Access Compliance Report

Public Rights-of-Way

(Curb Ramps)

Intersection ID: 10022282	Main Street: CAMBRIDGE BELTWAY DR	Cross Street: N/A	Location:	N
ADA ID: E783186CBC38	Ramp Type: PerpDiag	Initial Pass/Fail: Fail	Overall Compliance: No	Severity Score: 22.5
Codes/Mitigation Info/Possible Solution		Field Measurements/Component Compliance

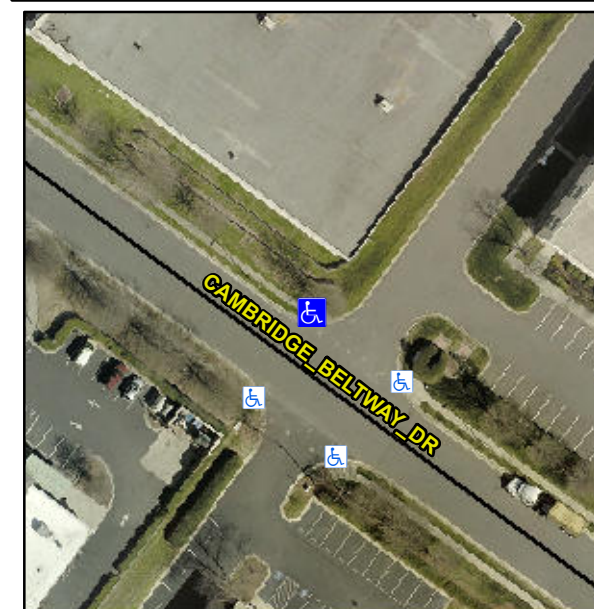
Not Found, R304.5.1, R304.2.2, R304.5.3

Compliance	Description	Data	Compliance	Description	Data
N/A	Ramp Length (in)	73.0	No	Ramp Slope (%)	10.5
No	Ramp Width (in)	37.0	No	Ramp XSlope (%)	3.5
N/A	Flare Type LT	N/A	N/A	Flare Type RT	N/A
N/A	Flare Slope LT (%)	N/A	N/A	Flare Slope RT (%)	N/A
N/A	Flare Traversable LT?	N/A	N/A	Flare Traversable RT?	N/A
N/A	Landing Length (in)	N/A	N/A	DWS Provided?	N/A
N/A	Landing Width (in)	N/A	N/A	DWS Contrast?	N/A
N/A	Landing Slope (%)	N/A	N/A	DWS Length (in)	N/A
N/A	Landing X Slope (%)	N/A	N/A	DWS Full Width?	N/A
N/A	Landing Curb? (Y/N)	N/A	N/A	DWS Offset (in)	N/A
N/A	Shared Landing?	N/A			
N/A	Gutter Ponding?	N/A	N/A	Gutter Slope (%)	N/A
N/A	Gutter Lip Ht (in)	N/A	N/A	Gutter X Slope (%)	N/A
N/A	Painted X Walk1?	No	N/A	Painted X Walk2?	No
	X Walk 1 Direction	To SW		X Walk 2 Direction	To SE
N/A	X Walk 1 Width (in)	N/A	N/A	X Walk 2 Width (in)	N/A
	X Walk 1 Slope (%)	0.3		X Walk 2 Slope (%)	1.0
	X Walk 1 X Slope (%)	1.2		X Walk 2 X Slope (%)	0.1

Remove & Replace Curb Ramp With Two New Directional Ramps or Equivalent.
